## MICROLIGHT AIRWORTHINESS APPROVAL NOTE

MAAN NO:1877

ISSUE 2

TITLE: Microlight Airworthiness Approval Note 1877, Shadow D, DD and D-SS aircraft, resolution of pitch circuit resonance (elevator flutter) concerns.

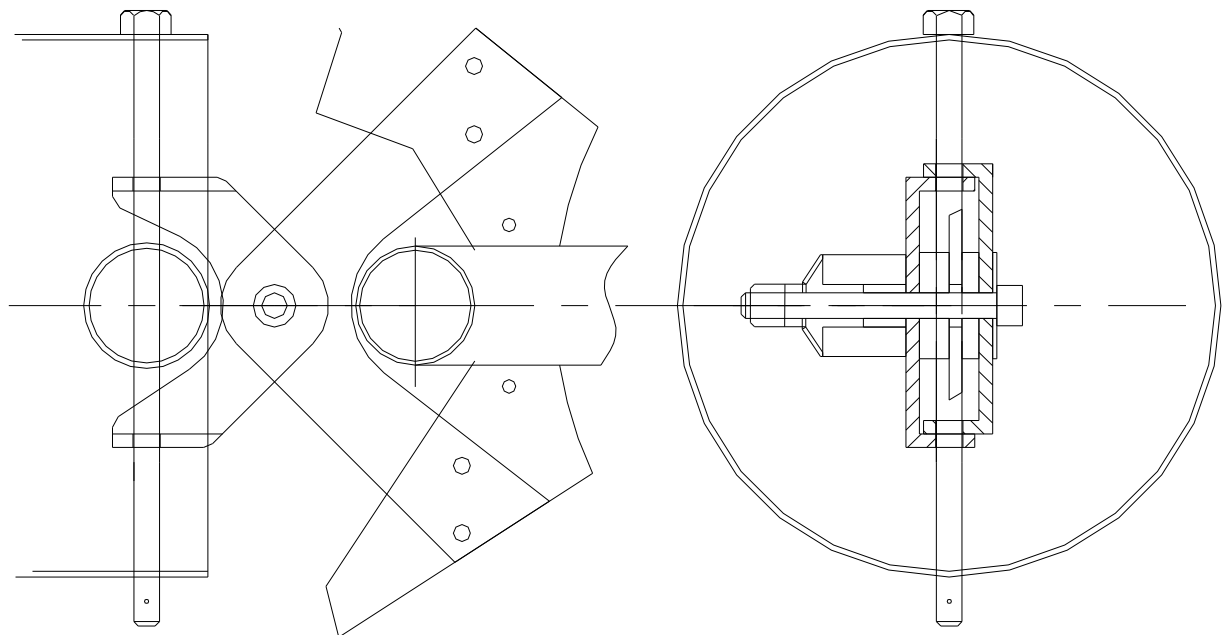
The device to be fitted to the aircraft consists of a series of greased nylon discs under compression, the tension on which may be adjusted, altering the rotating breakout+friction value. This is illustrated below:-

A pitch damping mechanism is introduced, fitted at the elevator control horn (rear of the aircraft boom tube, above the fixed horizontal stabiliser).
